ADDENDUM NO. 1

PROJECT TITLE:
**REPLACEMENT OF BRIDGE NO. 05585 - INTERSTATE 91
OVER GRAPE BROOK**

PROJECT NO.:
0048-0200

DRAWING TITLE:
INLET LAYOUT

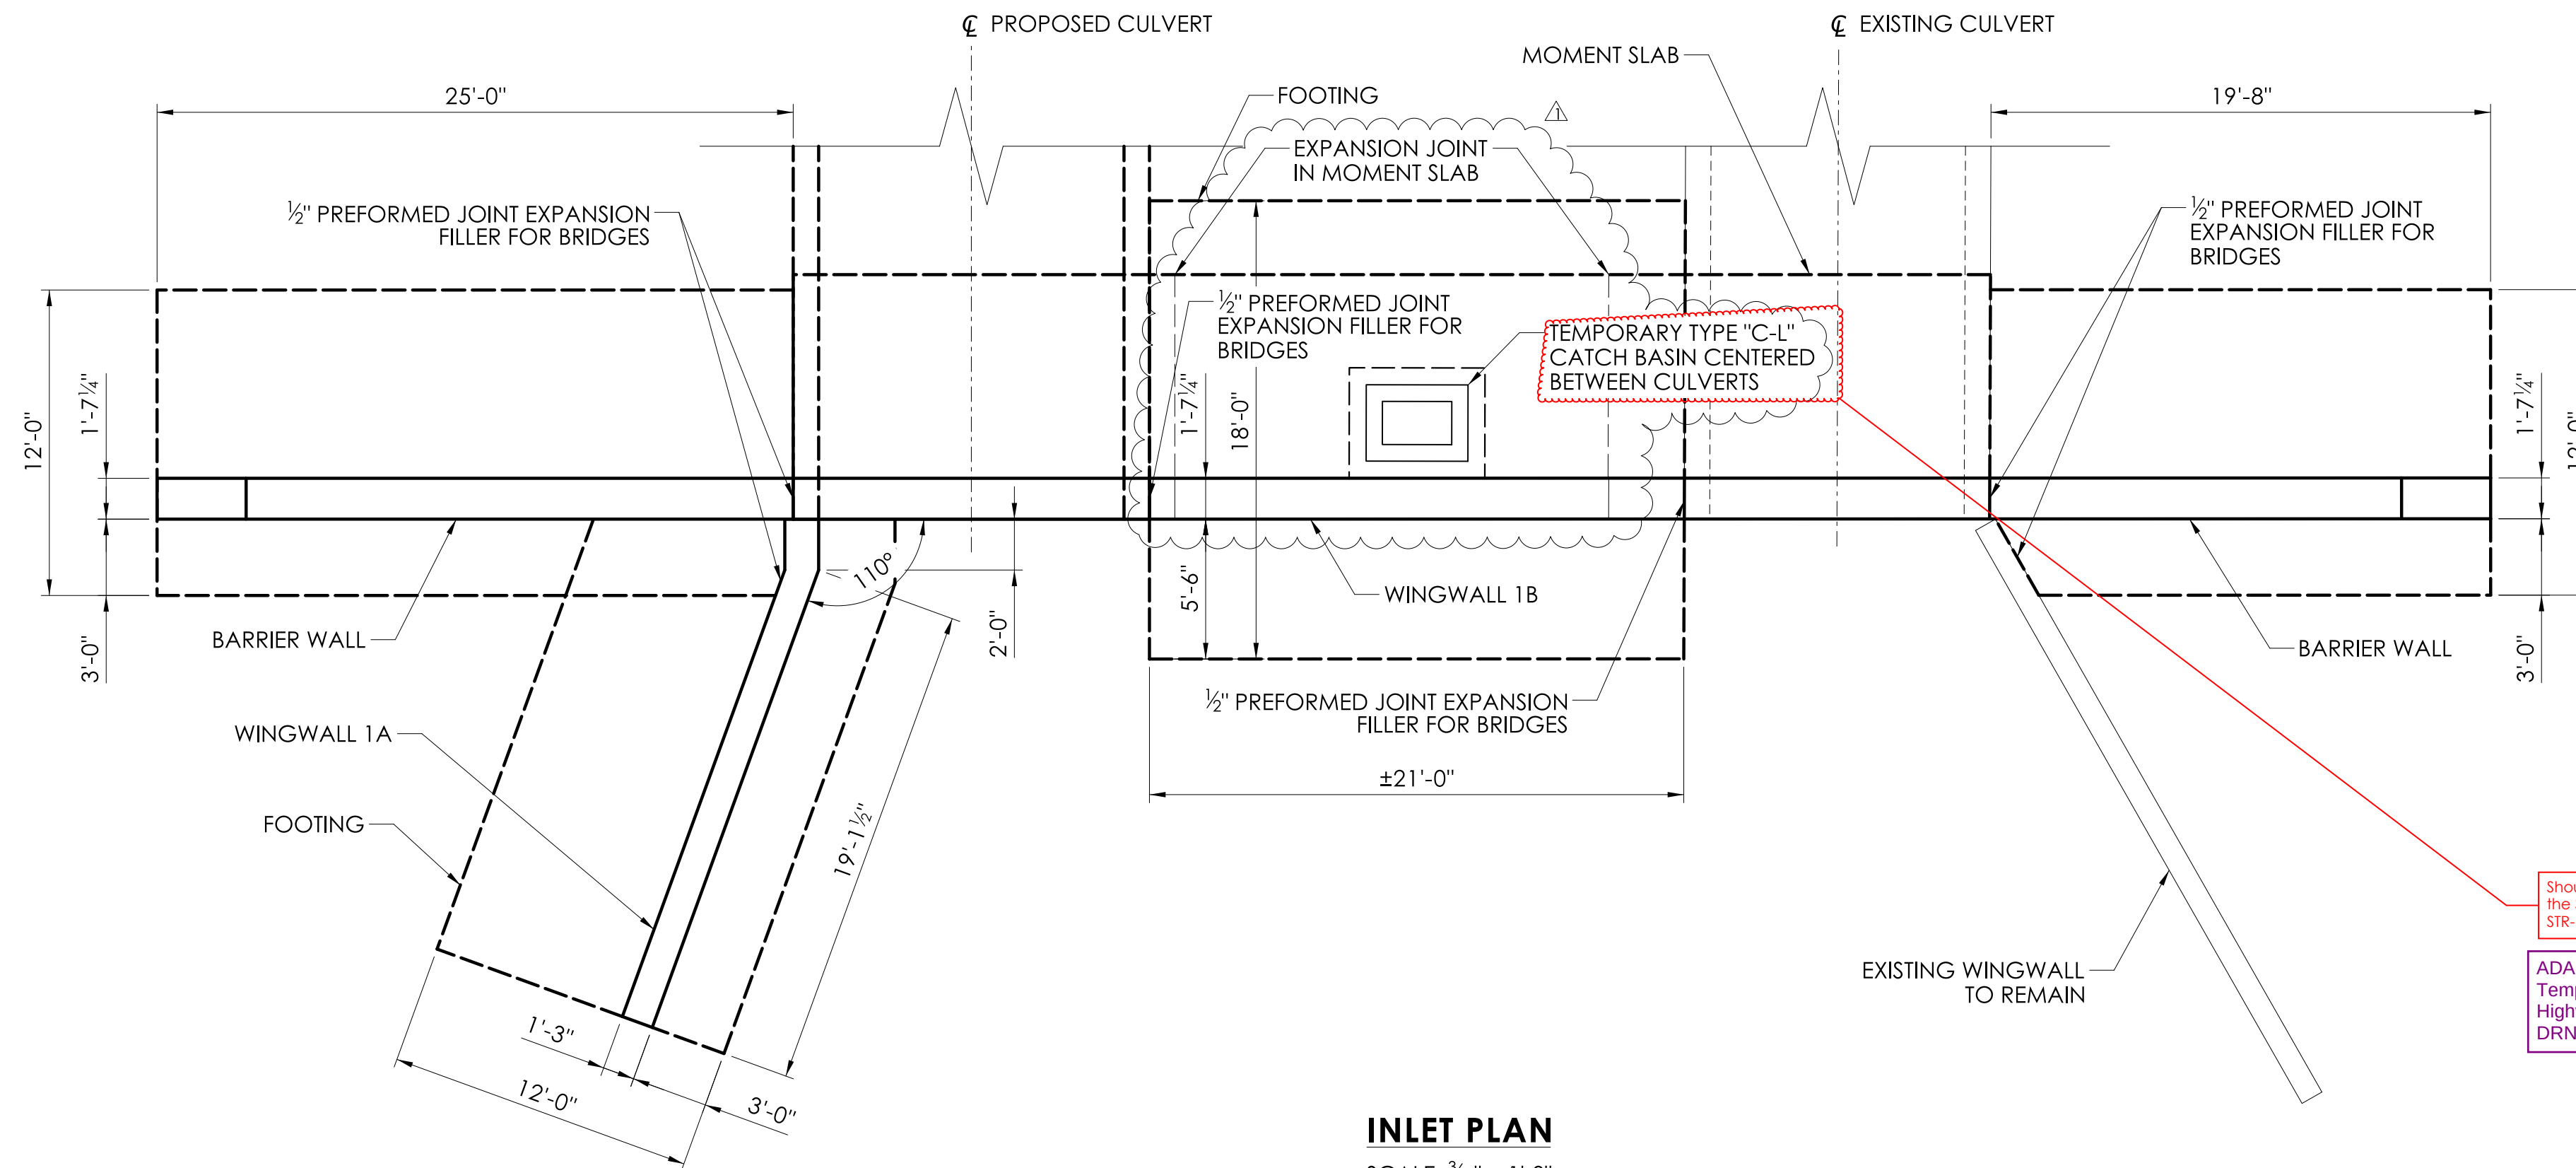
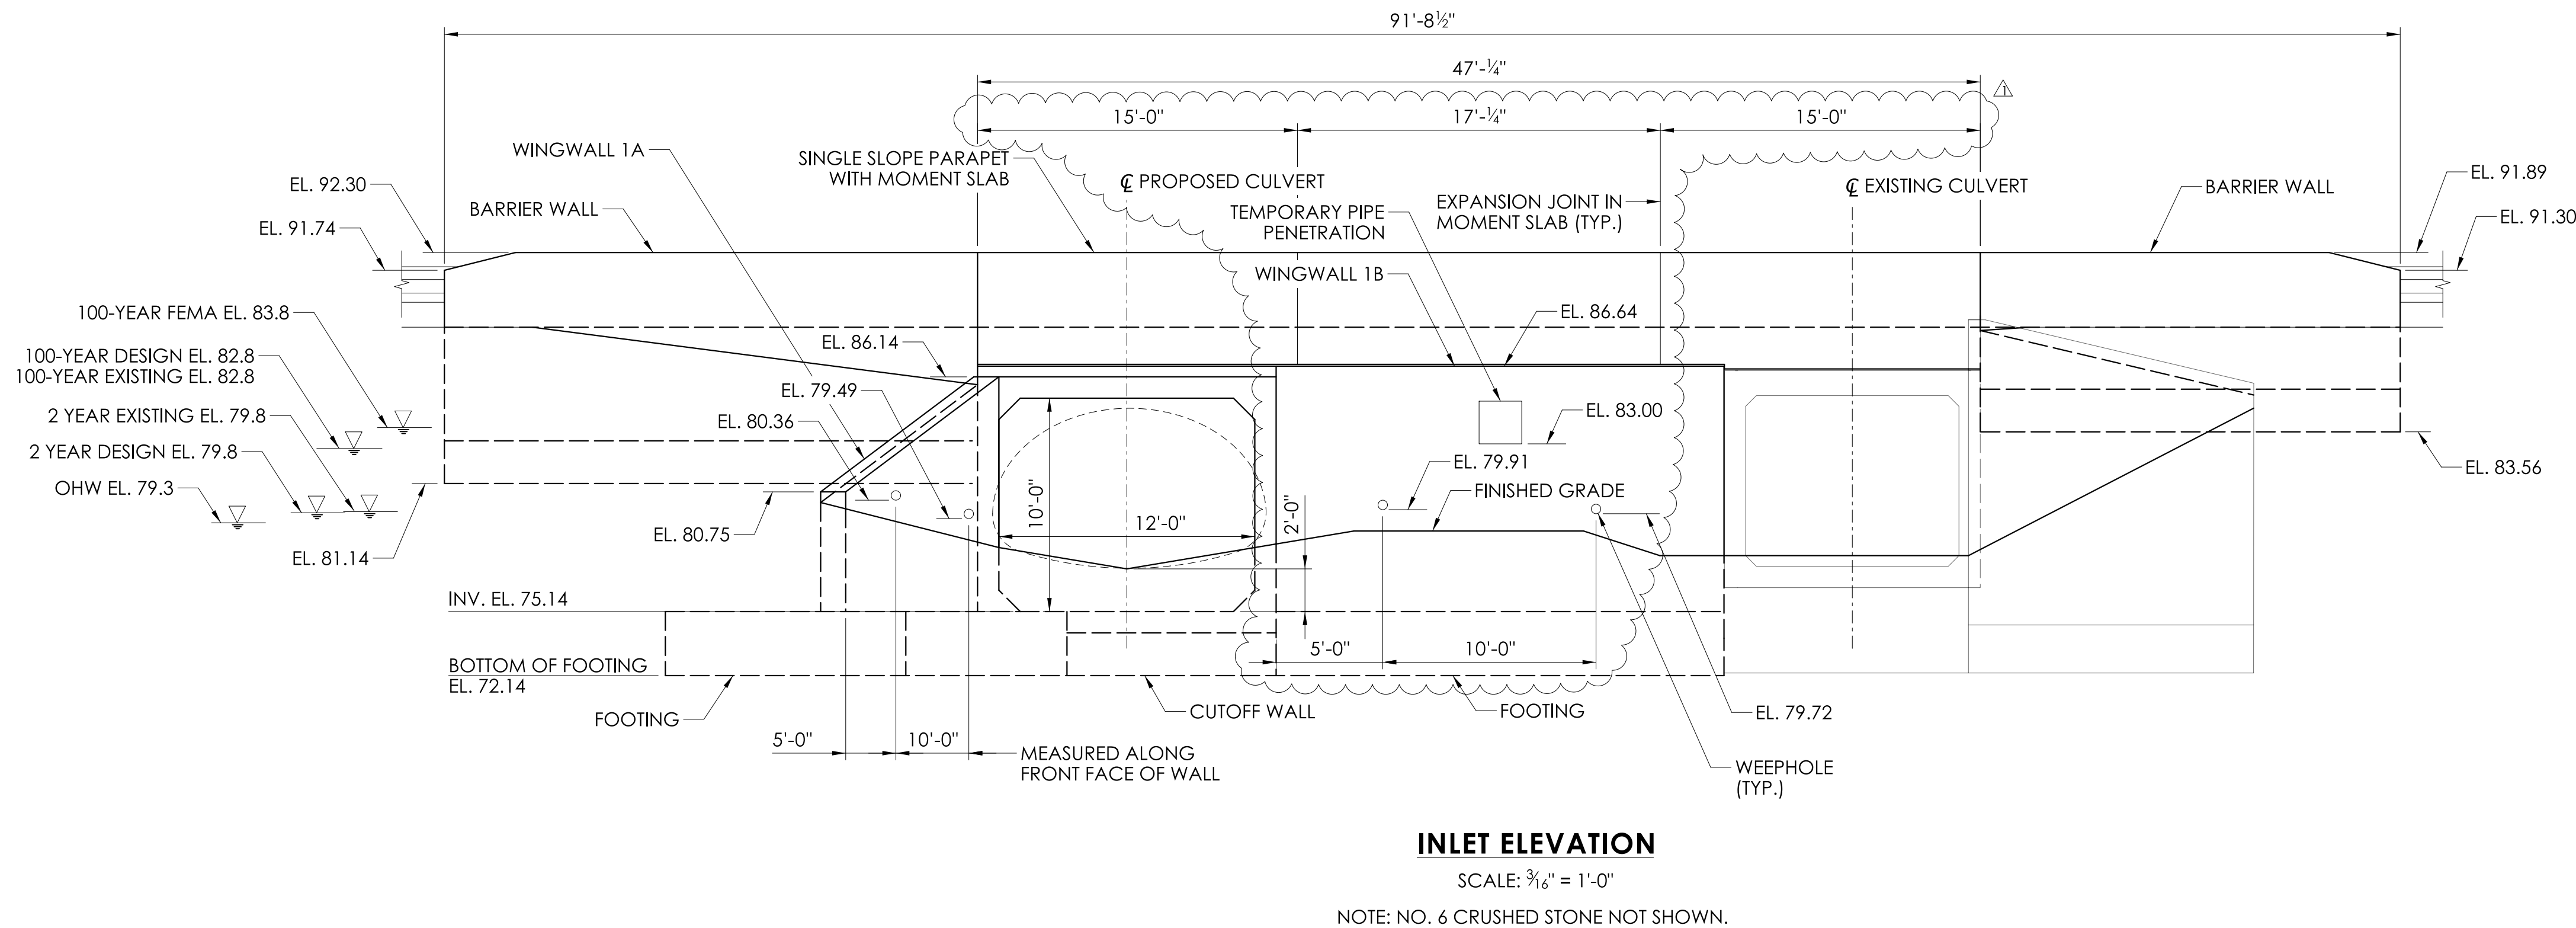
Should this CB be shown on the Stage Plans? STR-09, STR-10, and STR-11?

REV	DATE	REVISION DESCRIPTION
1	09/17/25	ADD TEMPORARY DRAINAGE STRUCTURES

ADA Response:
Temporary drainage information can be found in the Highway subset. Revise referring to DRN-01 thru DRN-09-6 for the temporary drainage layout.

DRAWING TITLE:
WALL DETAILS - 3

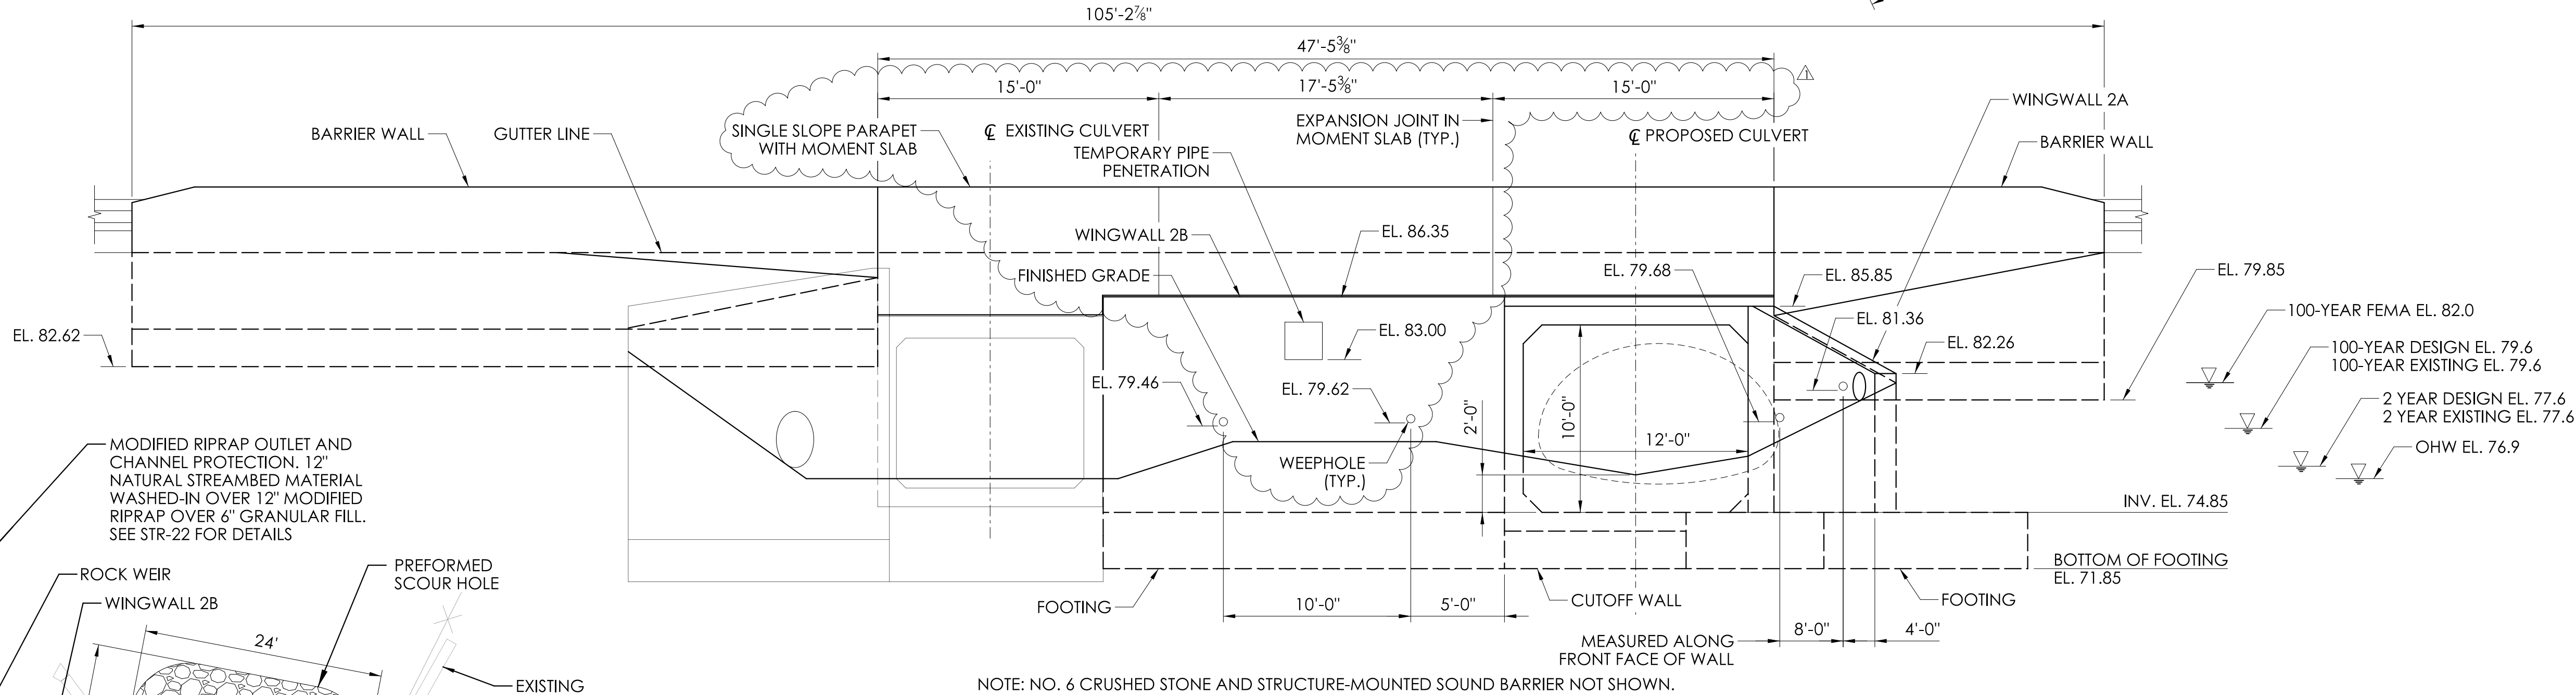
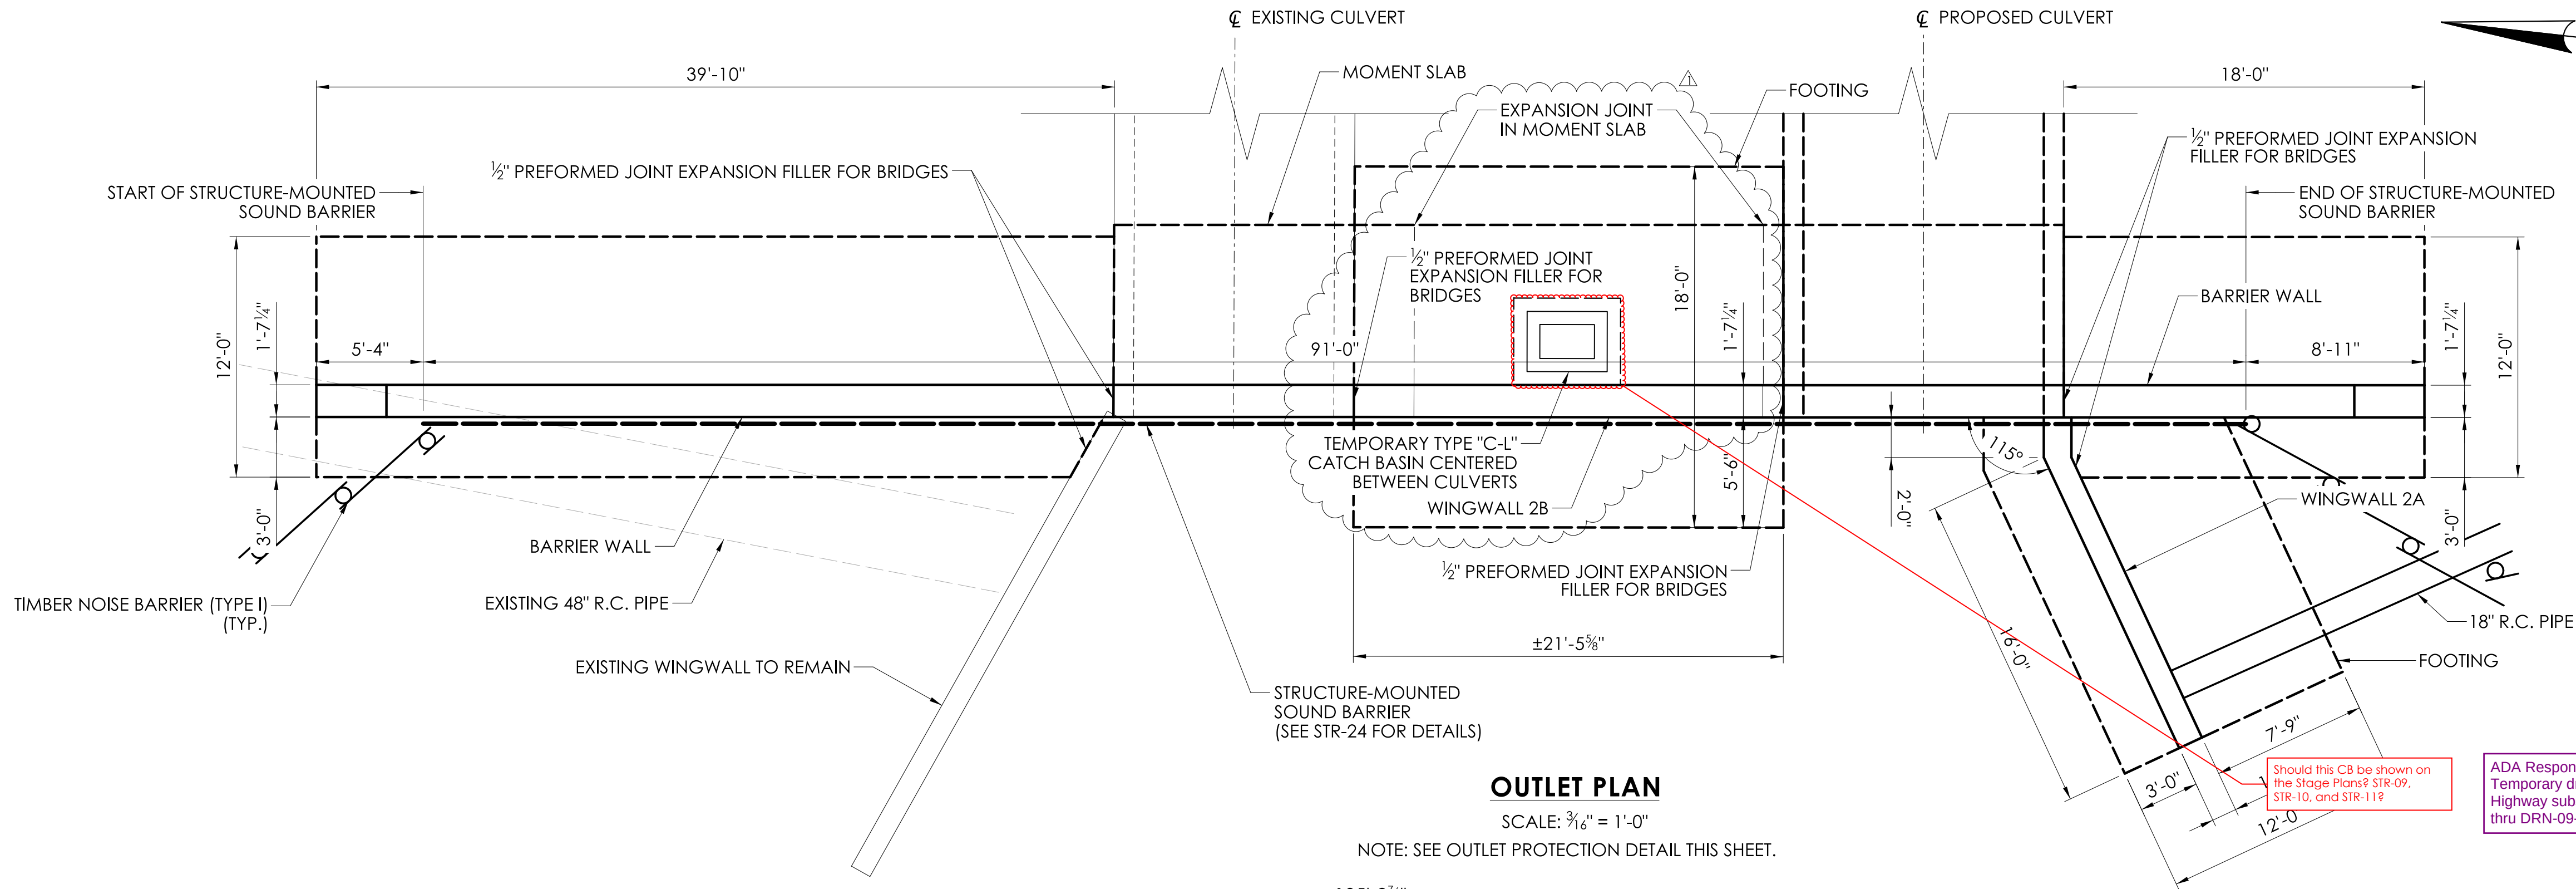
- NOTES:
- DOWEL BAR SPICER INSERTS SHALL BE PAID FOR UNDER ITEM "DOWEL BAR SPICER SYSTEM GALVANIZED".
 - 1/2" PREFORMED EXPANSION JOINT FILLER FOR BRIDGES PLACED BETWEEN THE TEMPORARY CATCH BASIN AND MOMENT SLAB SHALL BE PAID FOR UNDER ITEM "TEMPORARY DRAINAGE SYSTEM".
